From: Drew Dara-Abrams <dda@dara-abrams.com>
Sent: Sunday, May 22, 2022 9:48 PM
To: Gail Payne
Subject: [EXTERNAL] Transportation Commission re Grand Street

Dear City Officials involved with the Grand Street repavement project,

From: John Brennan <johnpbrennan@yahoo.com>
Sent: Monday, May 23, 2022 10:00 AM
To: Gail Payne
Subject: [EXTERNAL] Revised email and proposal

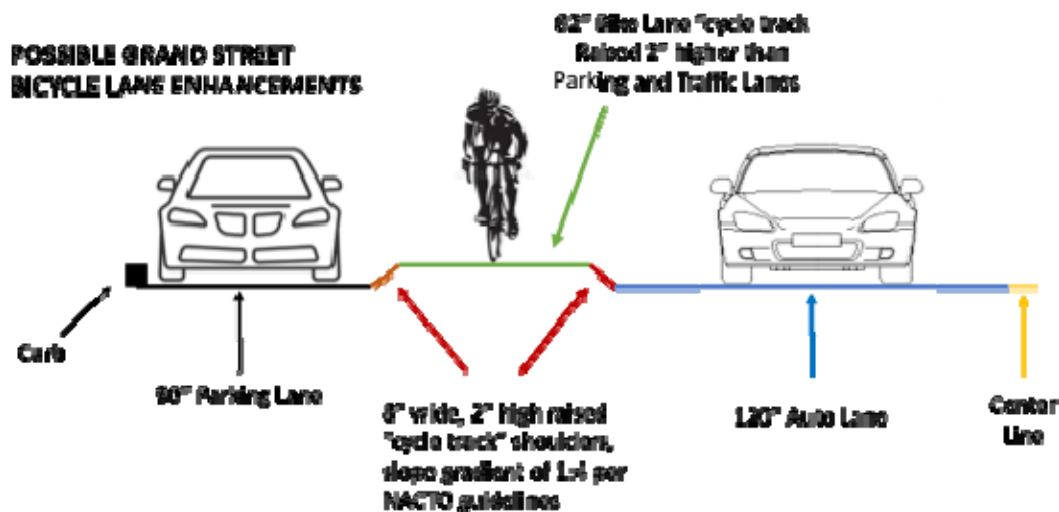
Looking at streets across the city where there are bike, parking and auto travel lanes (* below please see street measurements I gathered for this exercise), It appears feasible to have a 90" parking lane, 78" bike or bike/buffer lane and a 120" traffic lane for a total width of 288" on each side of the street. On Grand Street between Palmera Court and Encinal the parking plus bike lane (there is no demarcation separating the two) is 157" and the auto traffic lane is 133" in each direction, giving 290" available to design and construct bike, buffer, parking and traffic lanes.

So how best to design and build bike lanes that feel and actually are physically more distinct from the traffic lanes? Plan 1 includes vivid striping and green coloring of the lanes, which would be a significant enhancement. Even more helpful would be a raised bike lane, where the bike lane is elevated 2" relative to the traffic and parking lanes, with gentle shoulders on either side. This could be a huge enhancement for the bike lanes on Grand, as a raised bike lane will create a distinct lane for cyclists and a physical buffer alerting drivers when they are encroaching into the bike lane. The bike lane would still be sited between the parking and auto traffic lanes, but now with real physical—not just visual—delineation of the bike lane.

The diagram below demonstrates how this could work on Grand Street. It has a 90" parking lane at the curb (* wider than Shoreline or Blanding—see measurement footnote below), an 8" buffer ramp "shoulder" rising to a raised bike lane 2" higher than the adjacent parking and traffic lanes (using a 1:4 shoulder ramp gradient ratio per NACTO guidelines), a 62" bike lane, followed by another 8" buffer "shoulder" ramp back down to the auto traffic lane. This provides a total of 78" of width between the parking and traffic lanes. This then allows for a 120" traffic lane, which is wider than Encinal east of Grand, and the same width as Santa Clara between Oak and Grand and Blanding between Tilden and Park. The 8" wide, 2" high shoulders on the bike lane are easily navigated by cyclists, but are a deterrent to motorists (both in the auto traffic and parking lanes) from encroaching on the bike lanes.

The auto traffic lanes would be about the same width as on Shoreline, but would feel wider since traffic would not be driving so close to parked cars. Drivers would be able to see cyclists when turning into driveways and side streets. Evidently the raised lanes can be continuous or can be discontinued adjacent to driveways and side streets to allow for stormwater drainage.

Otis to Encinal Typical

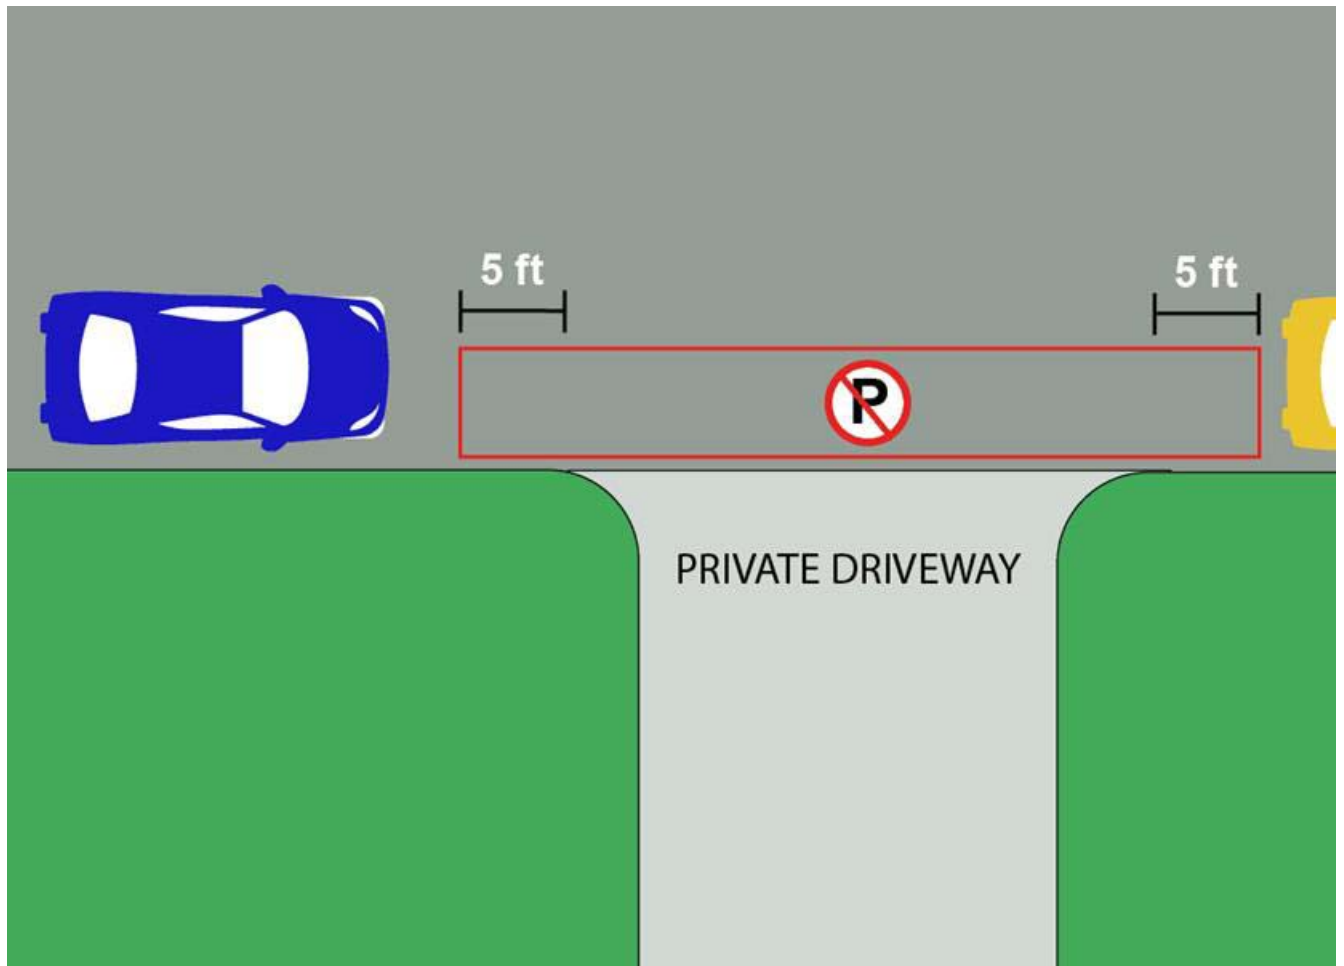
1. Vehicles in driveways should not be permitted to pull out into traffic in reverse
Even worse, is backing out and crossing a lane to enter the far lane on the other side of the street, as I have often observed

Instead, they should park by backing into the driveway, rather than potentially injuring pedestrians or cyclists because of limited visibility sectors

Driving into the street nose first makes it much easier for the driver to scan any approaching vehicles as well

6. What would also enhance safety, where a parking lane exists, would be to drop parking spots adjacent to a driveway
Such locations, if occupied by a vehicle, make it difficult for a driver exiting his driveway to ascertain whether the street is clear
Instead, such drivers will hesitantly poke into traffic or take their chances, without really knowing how safe it is
